RFP Title: Education Center and Pavilion for the Roger Williams Park Zoo

Addendum # 1

New Education Center & Events Pavilion
at the Roger Williams Park Zoo
1000 Elmwood Ave., Providence, RI 02905

September 6, 2023

A-L1.5

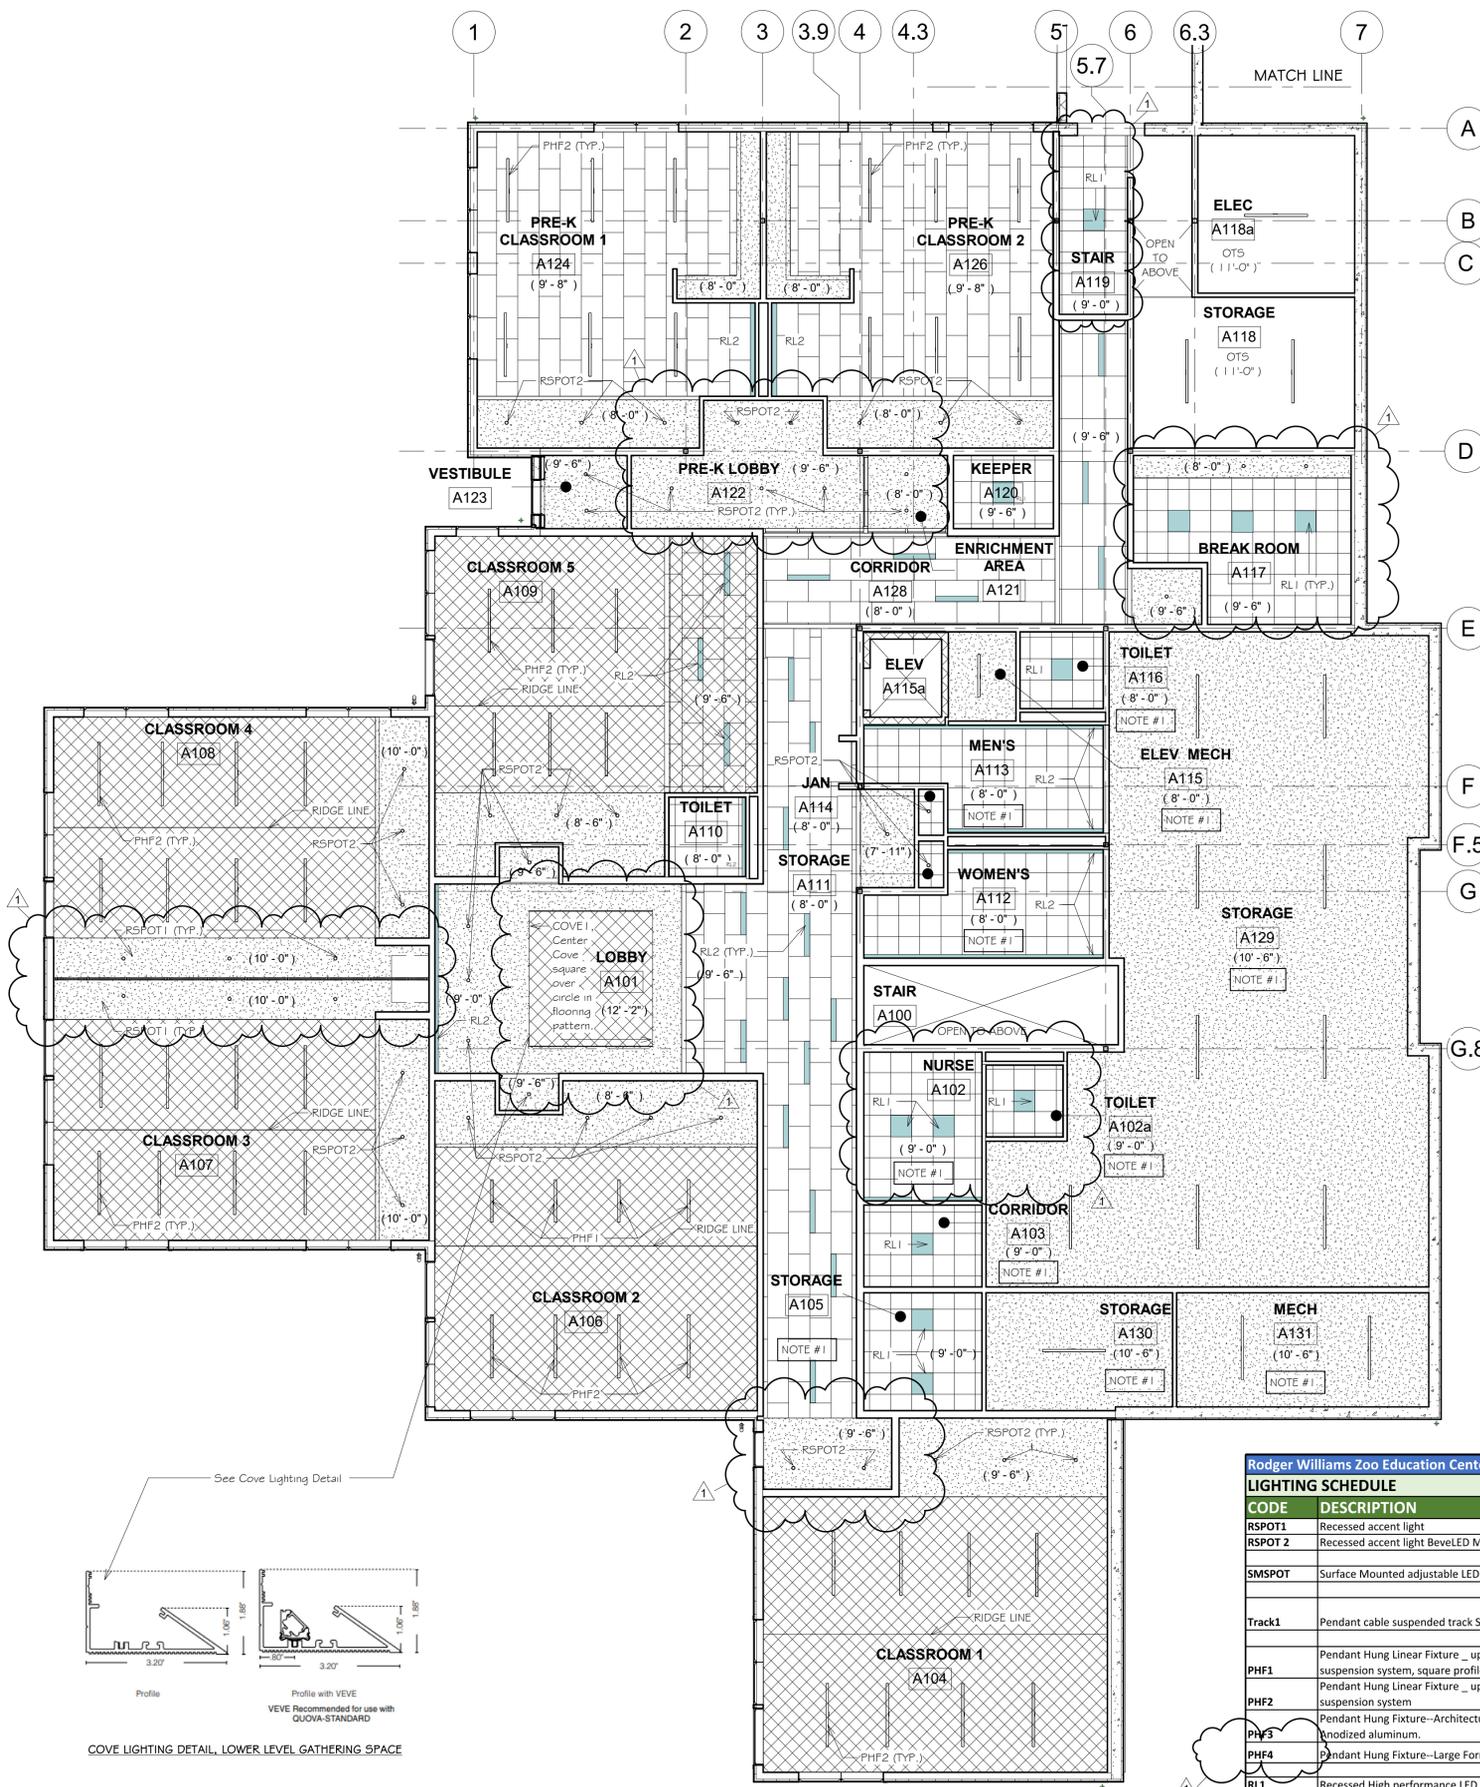
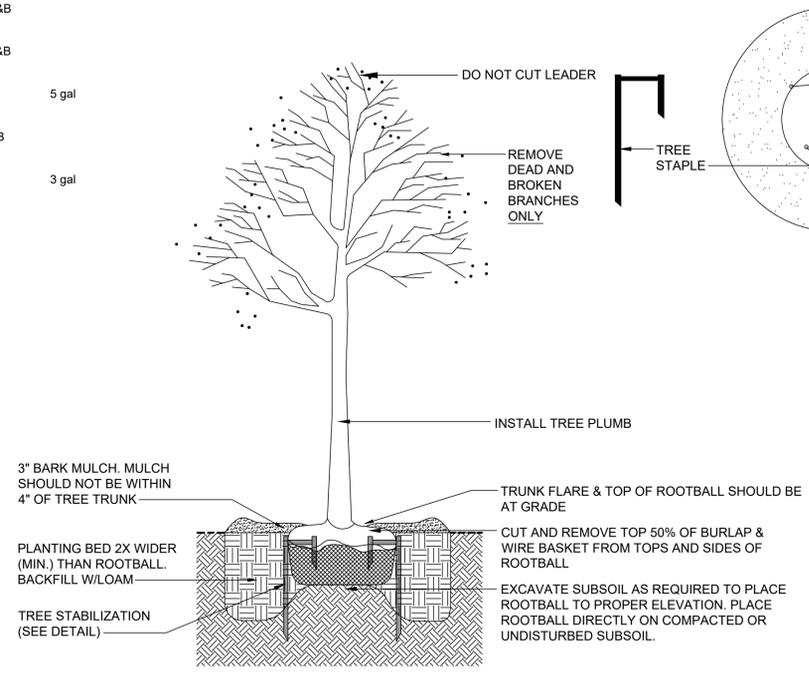
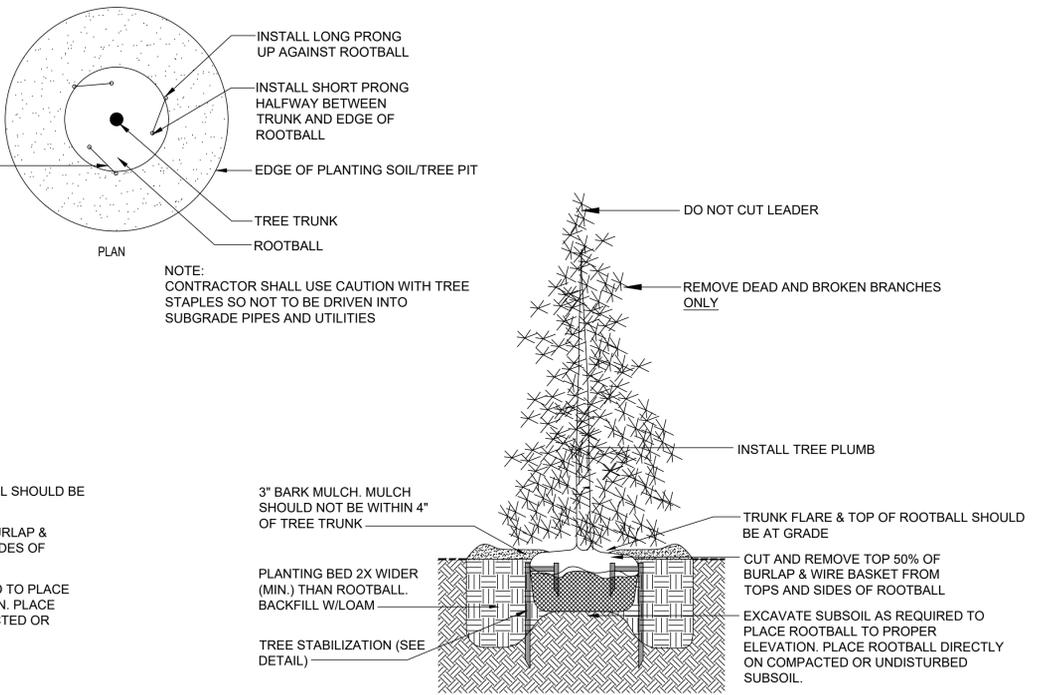
17. Question: Please provide a plantings list to coordinate with the planting layout.
Response: See sheet A-L1.5 which has been provided as part of this addendum.

Response: Where there are conflicts use A-A9.1.
36. Question: Planting Plan A-L1.5 appears to be missing; please provide.
Response: A-L1.5 was missing from the original set of drawings. See attached.

A-A8.1

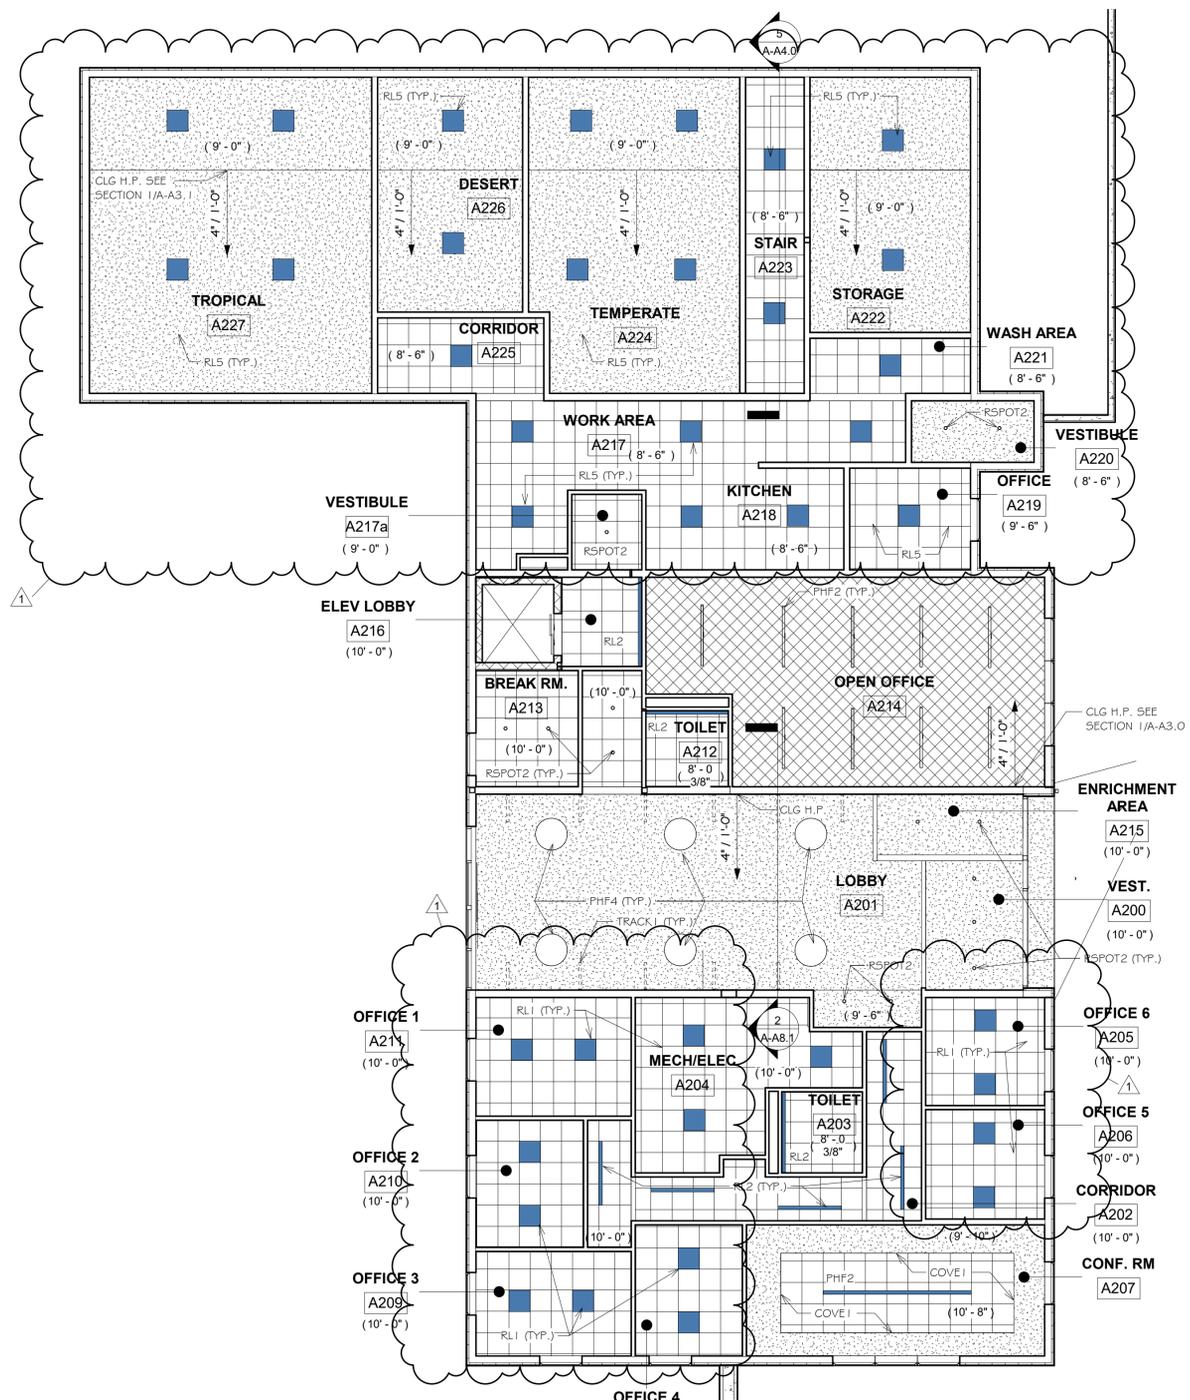
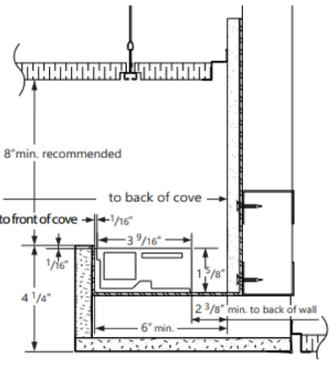
ITEM NO. 4 – DRAWING A-A8.0 and A-A8.1

- A. Change the lighting layout as shown on the revised drawings attached for locations.

- A. Remove the following drawings and replace them with revised drawings attached to this Addendum.
 - A-A8.0 Lower-Level Reflected Ceiling Plan
 - A-A8.1 Upper-Level Reflected Ceiling Plan
